November 25, 2014

Imperial Metals Ltd.  
580 Hornby Street  
Vancouver, British Columbia  
V6C 3B6

**DSR - North Starter Dam**  
**Independent Third Party Review**

**Figure 3.1 Typical Section for NSD**

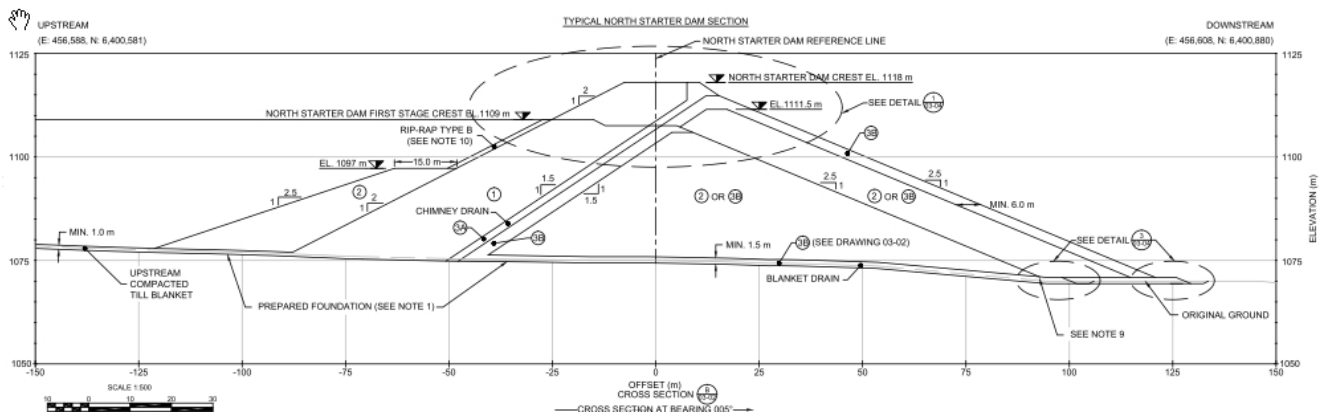
A typical design section through the dam is shown in Figure 3.1. The NSD at a final crest elevation of 1118 m will be 43 m high with a 2.5H:1V downstream slope and the same upstream slope to El. 1097 m and 2H:1V above that. The dam was constructed to El. 1097 m in 2013. At the time of our site visit in September 3 and 4, 2014, the 2014 dam construction was just starting with the intention of raising the dam to at least 1104 m in 2014 and as high as 1109 m, weather permitting. We do not know the current height of the dam.

The dam section comprises an impervious sloping core (Zone 1), a filter (Zone 3A) and a drain (Zone 3B) with a supporting downstream granular shell. The filter/drain opposite the core is connected to finger drains which convey seepage to the toe of the dam. There will also be riprap on the upstream slope down to El. 1109 m.

The dam rests on dense, granular glacio-fluvial sediments to depth of 80 m. An impervious blanket extends from the core upstream to limit seepage gradients through the pervious foundation soils. As well as data from test hole logs the writer observed dense outcrops of sands and gravels upstream of the dam in exposed borrow areas. There were no indications of lacustrine deposits in the test hole logs or in the outcrops.

For this 2.5H:1V downstream slope with a dense granular foundation and properly functioning filter and drains, the Factor of Safety will be well in excess of 1.5. The static factor of safety for the existing condition, crest at El. 1097 m, was checked by the writer using Bishop and Morgenstern (1960)<sup>3</sup>.
